Re: North Campus Facilities

Subj: Change Proposal No. 233901-0008

RFC No: 05
Date: 5/4/2017
Description: RFI 40 Transformer Bollards

RFI NO: 40

ELECTRICAL LAYOUT FOR:

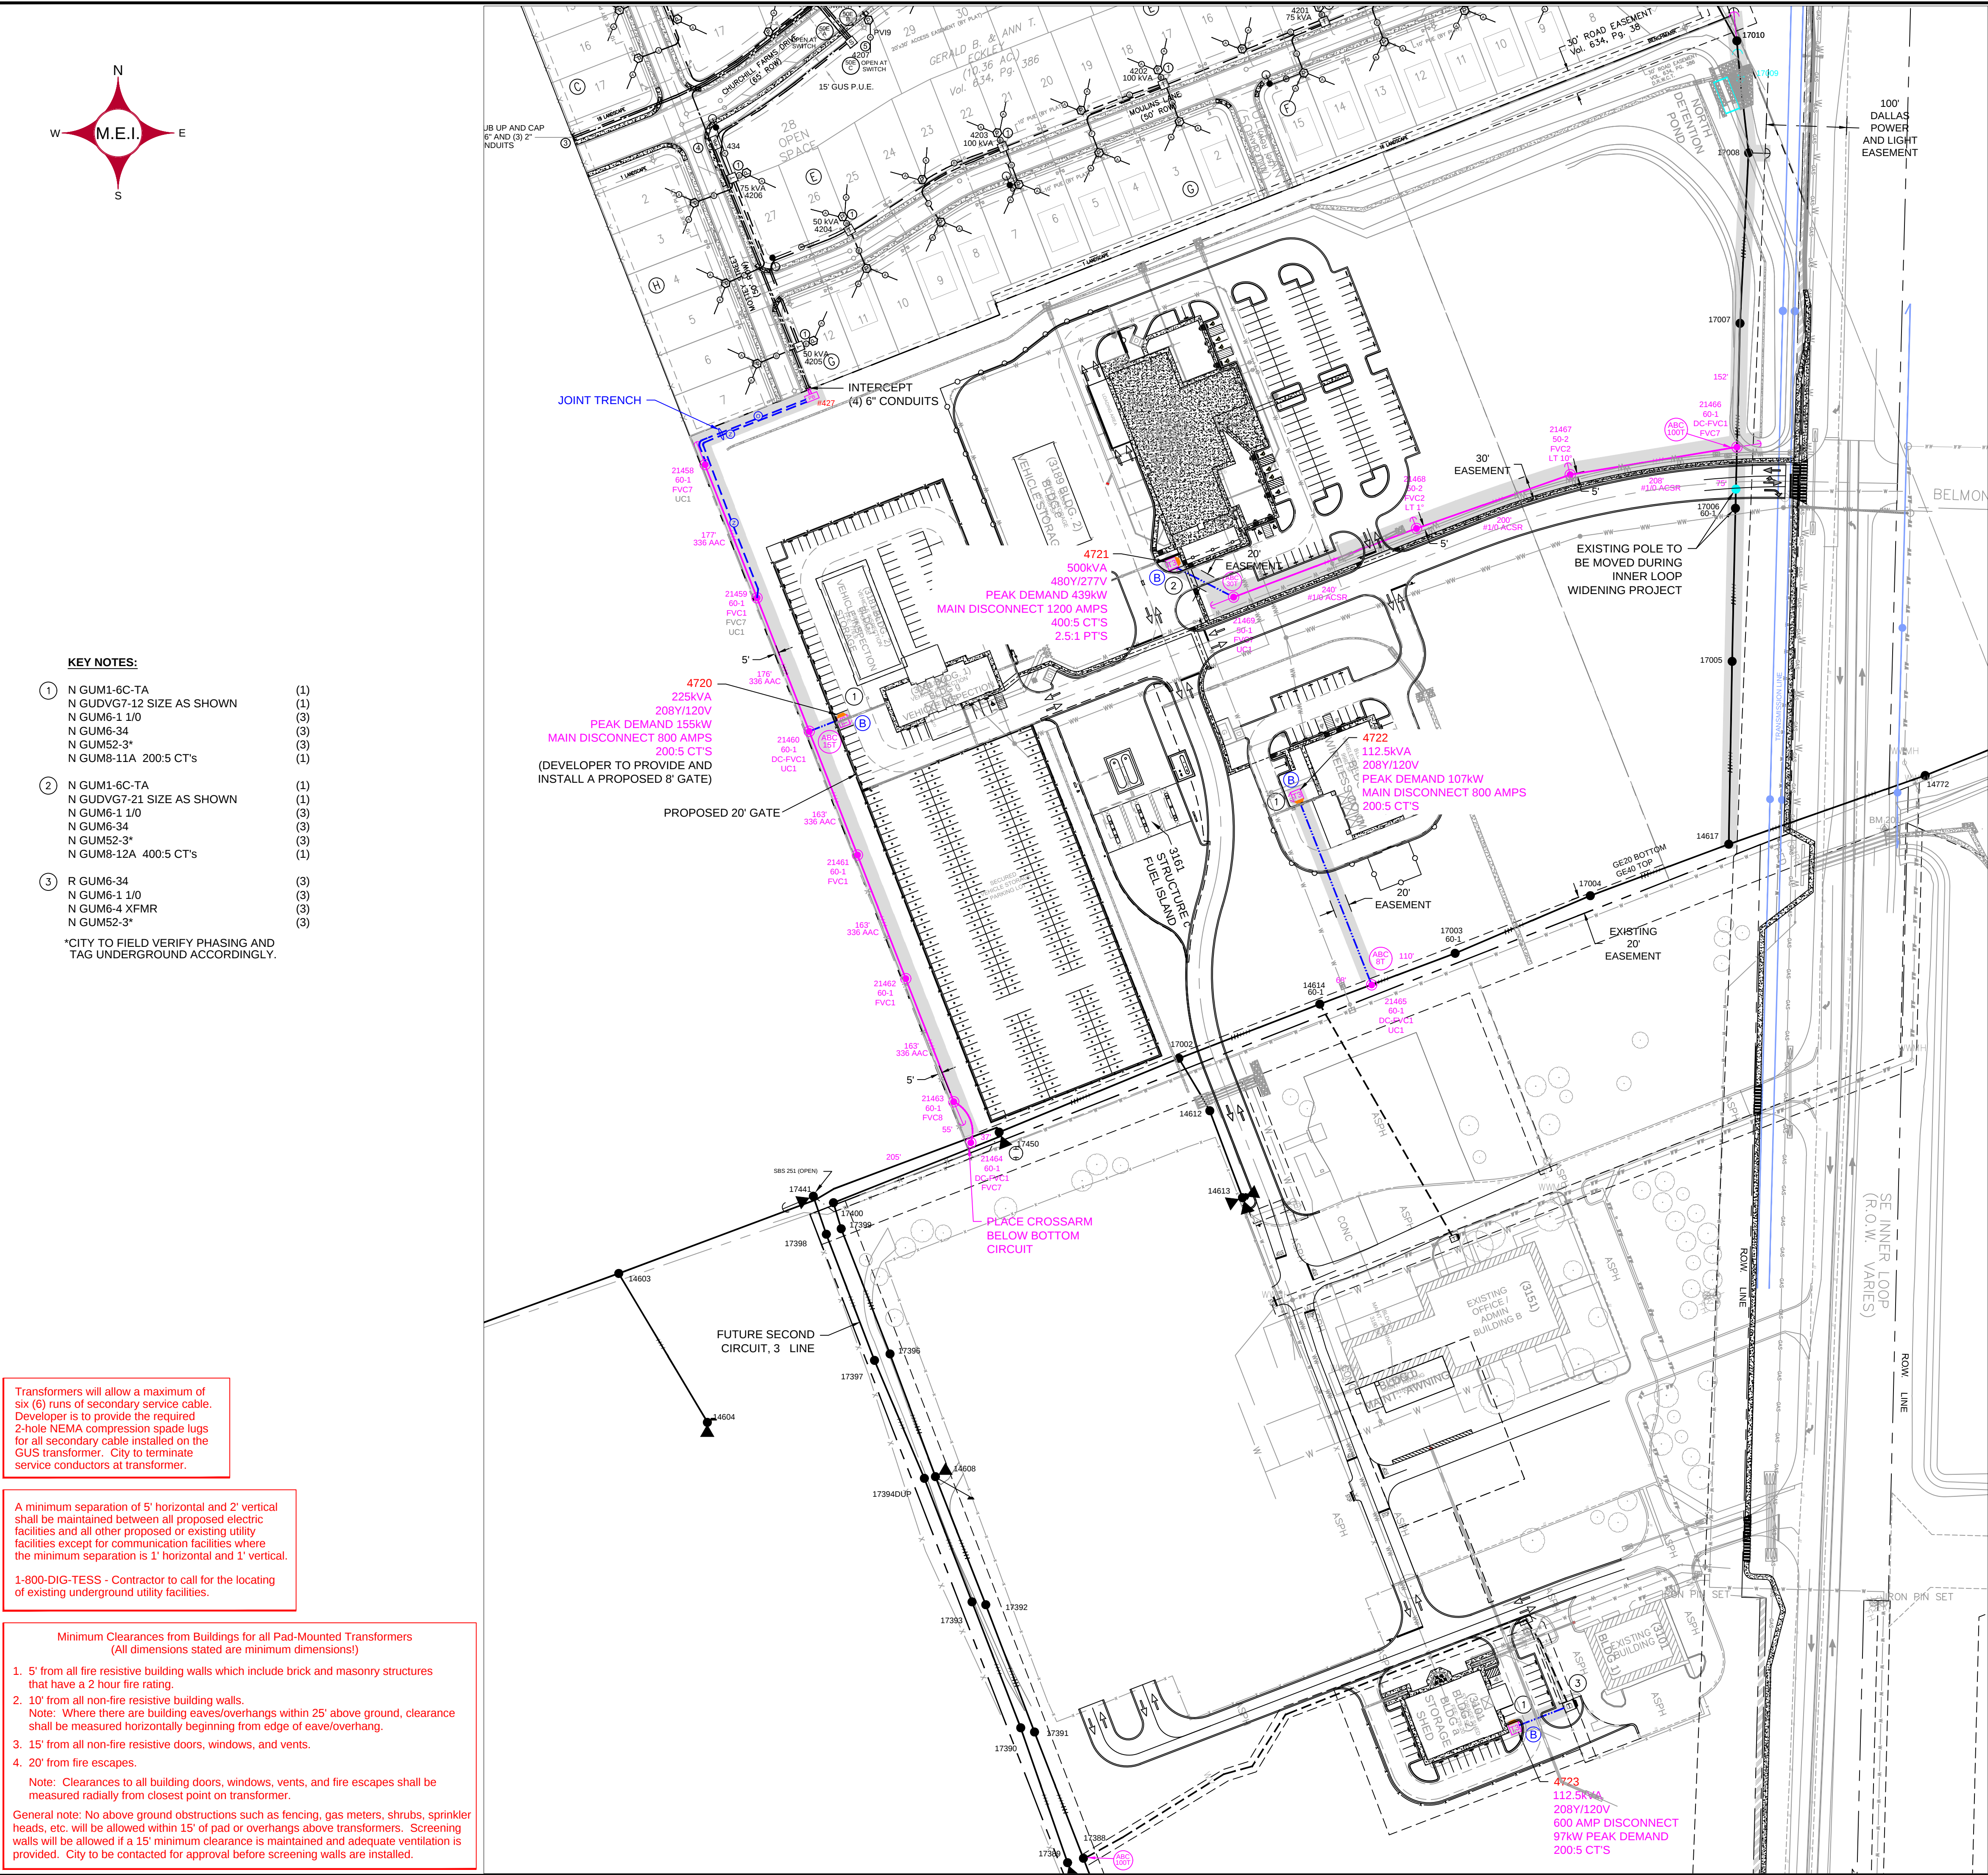
In the attached Power Pole layout, the City of Georgetown utilities run directly on top of the water line at the North side of Drive A. Please advise.

Also, there is to be a guy wire running directly across sidewalk based on coordinates captured which tie back to the civil drawings. Please advise.

Please see the attached drawing showing the power poles in a new location 5 feet from the proposed water lines. The guy wires have been modified as well to not cross the side walks.
